## THE CITY OF DAYTONA BEACH

ISSUE	DATE
	BID SET	4.7.20
3	ADDENDUM 3	5.12.20

## CAMPBELL **POOL ENTRY PAVILION AND POOL AREA IMPROVEMENTS**

SIDEWALK DETAILS / SCALE: NTS

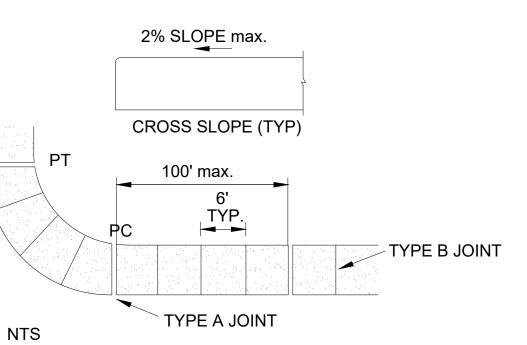
1/2" THICK X 2 1/4" TALL CONTINUOUS STEEL FIN WITH  $\frac{3}{16}$ " FILLET WELD CONTINOUS ALONG LENGTH (BOTH SIDES) (ADJUST HEIGHT AS NEEDED FOR ROOF SYSTEM DRIP EDGE) (SUBMITTAL REQUIRED FOR APPROVAL BY ARCHITECT)

FIRESTONE UC3 METAL ROOFING OR EQUAL. COLOR: CITYSCAPE.

METAL ROOFING OVER 5/8" CDX OVER 2X6 FRAMING @ 12" O.C.
